# **RANCHO SANTIAGO COMMUNITY COLLEGE DISTRICT**

## **ADDENDUM NO. 1**

**Bid # 1458 Fire Systems and Code Repairs Project  
at  
Santiago Canyon College**

**June 17, 2024**

**F-610**

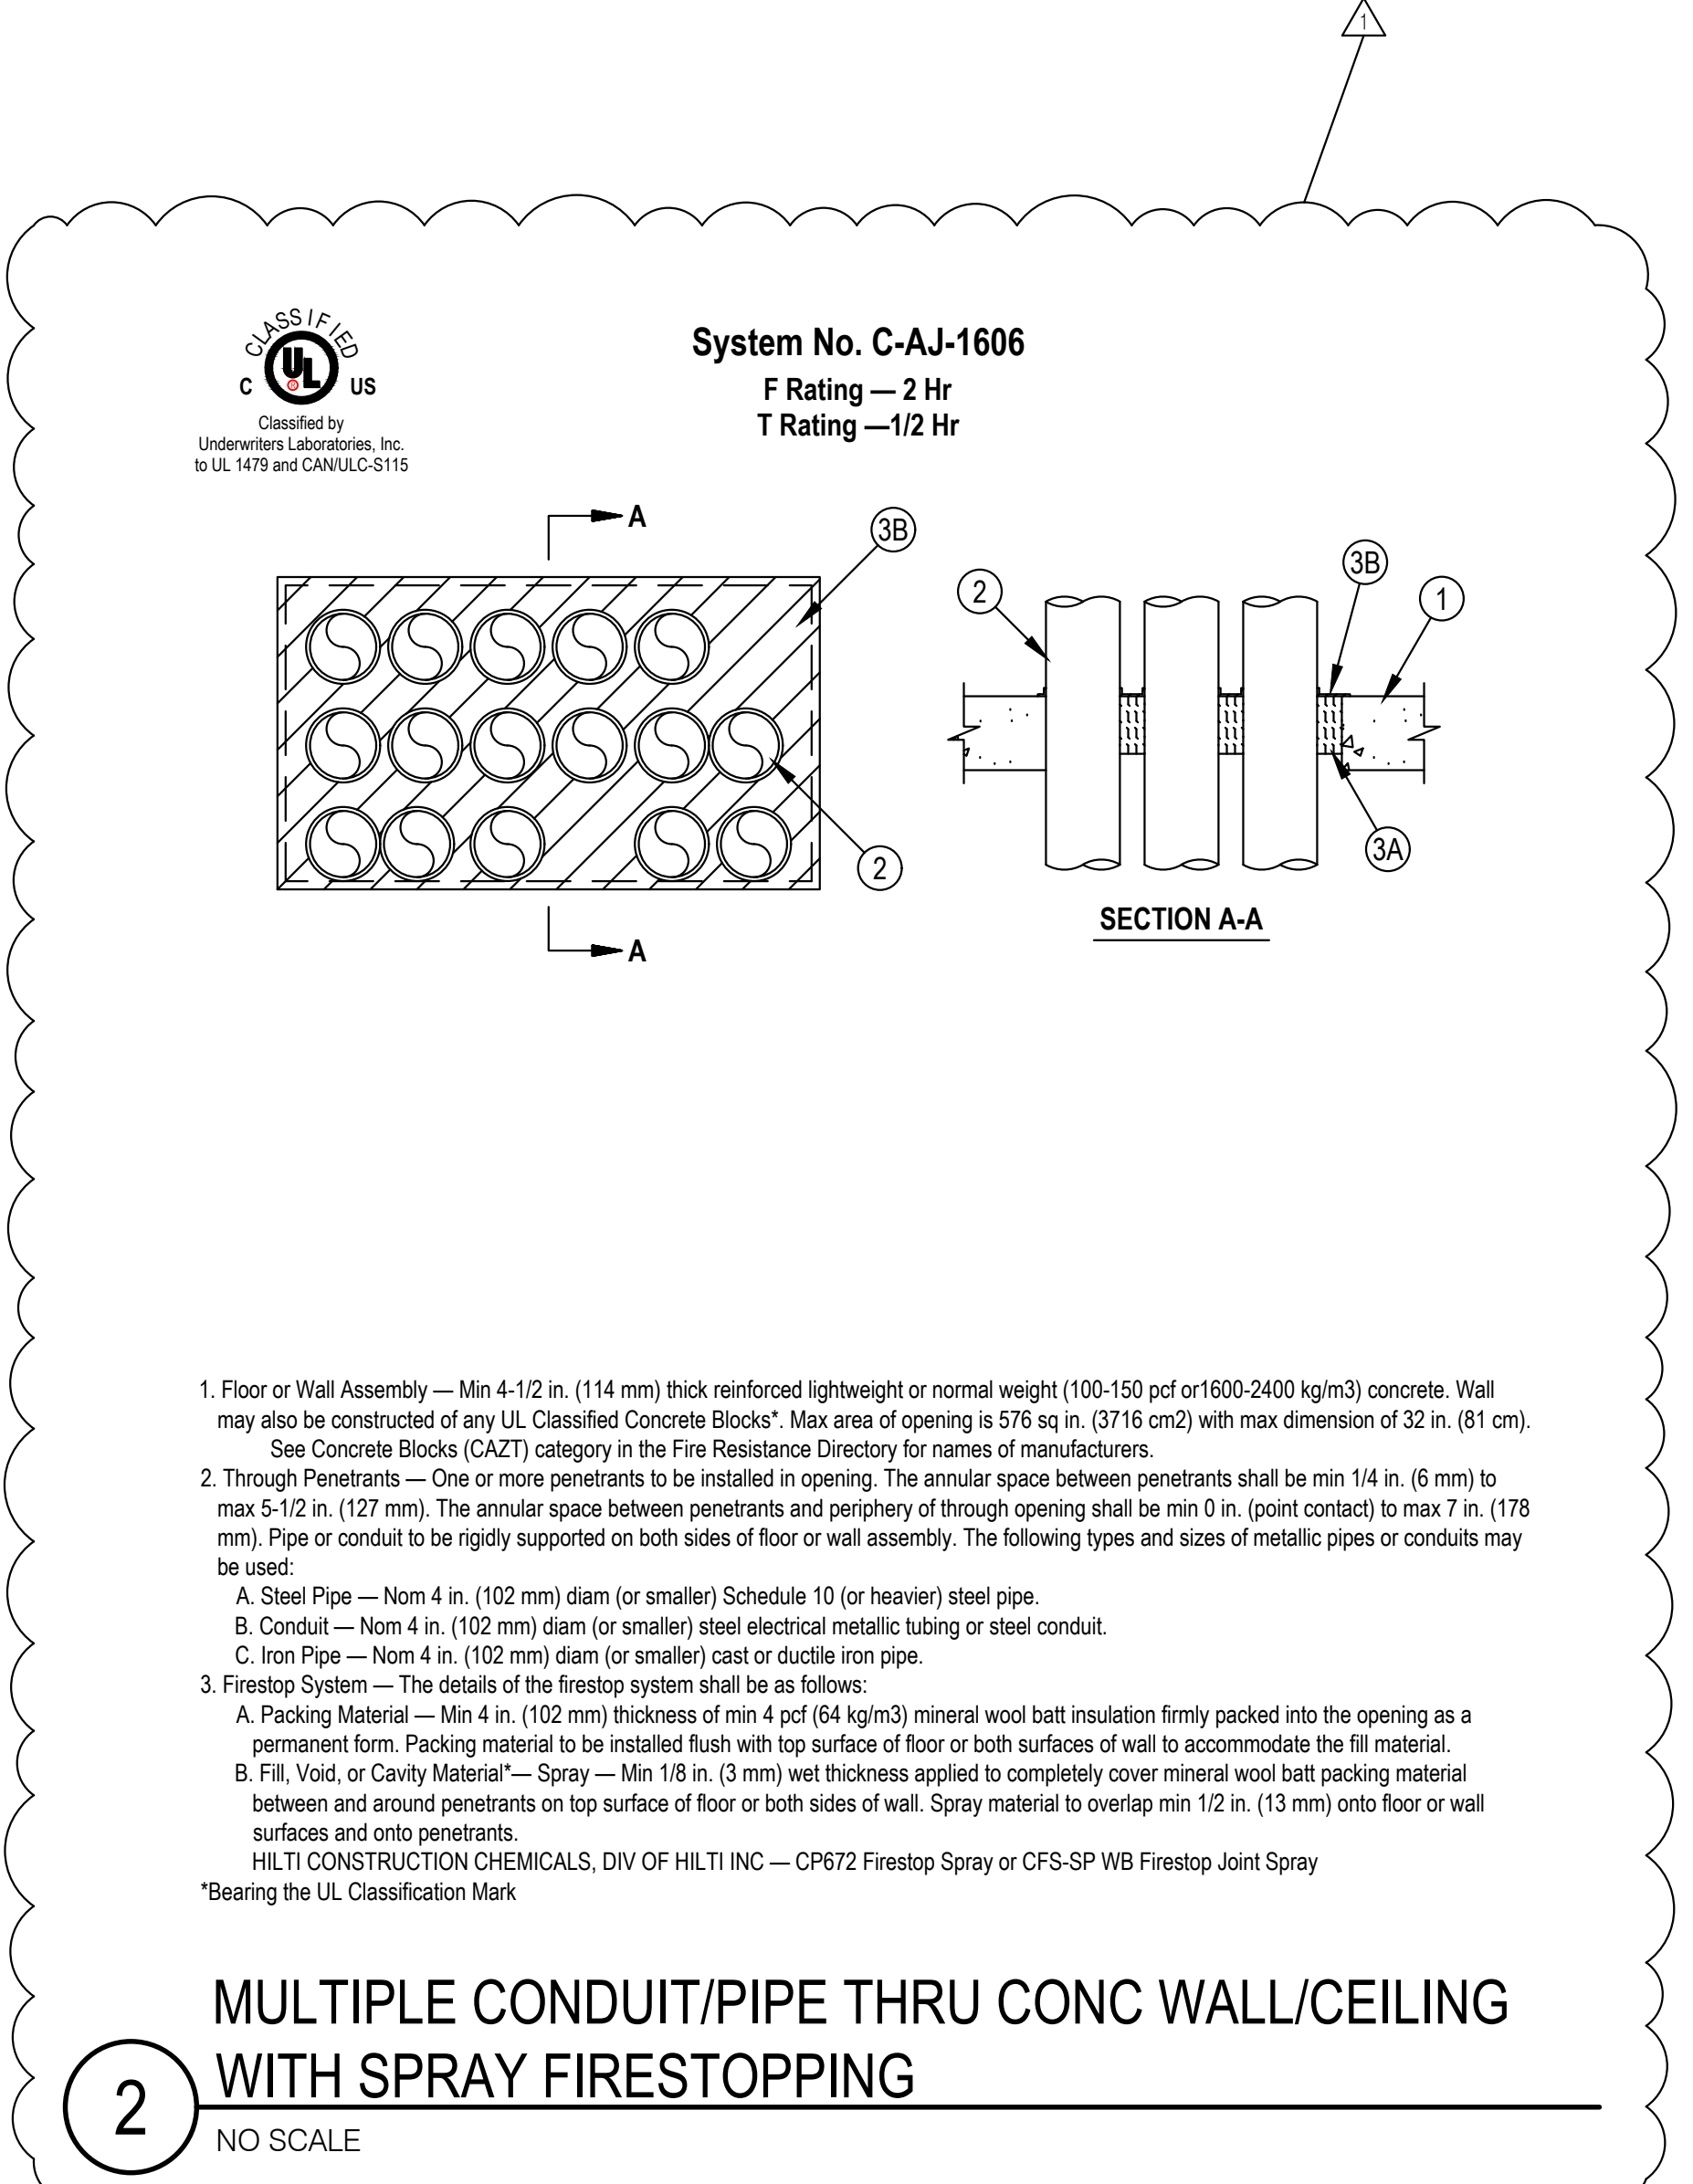
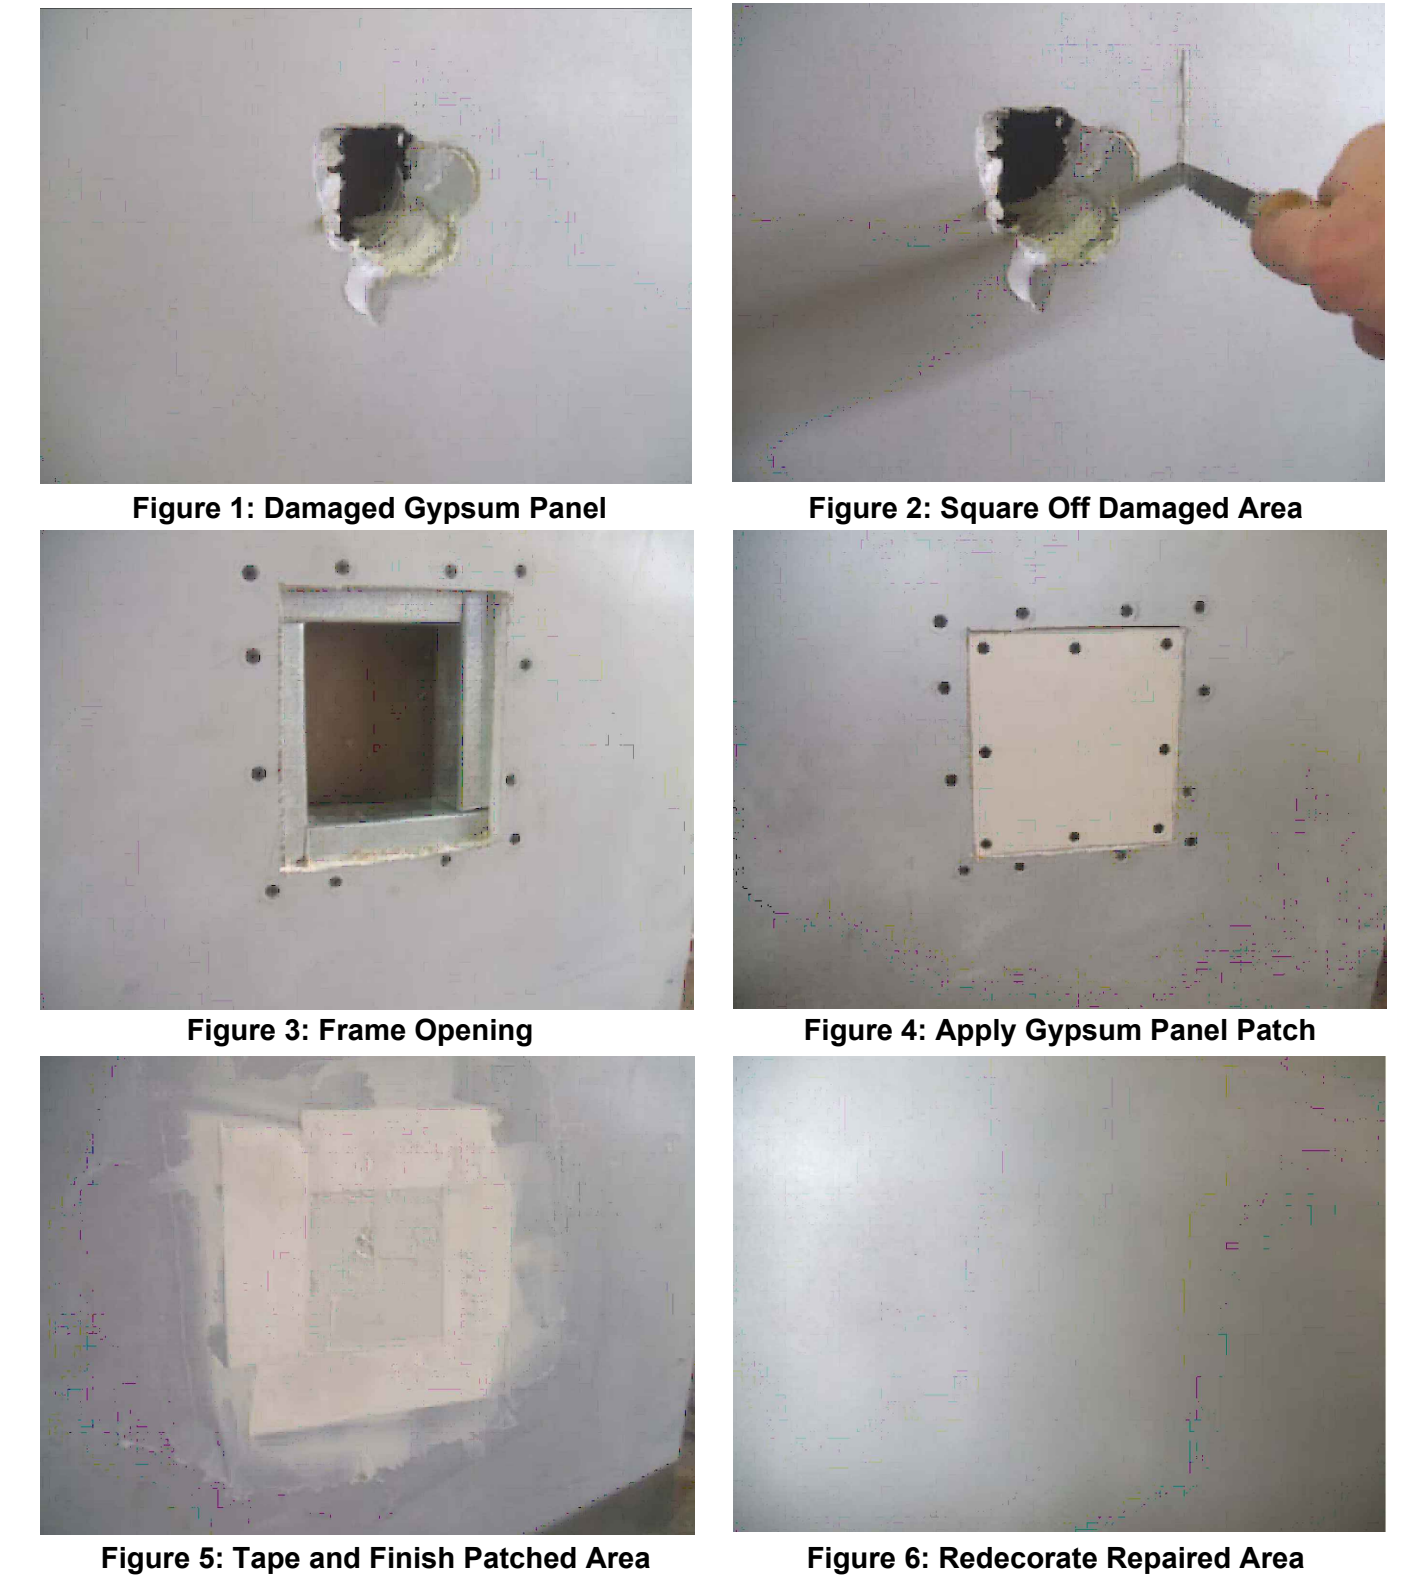
Drawings: Replace drawings F-002, F-603, and F-610 with their respective updated drawing sheets. See attached below.

**3** ENGINEERING JUDGMENT - ELECTRICAL BOX IN GYP WALL  
 NO SCALE

**1** FIRE-RATED GYPSUM BOARD WALL REPAIR DETAIL  
 NO SCALE
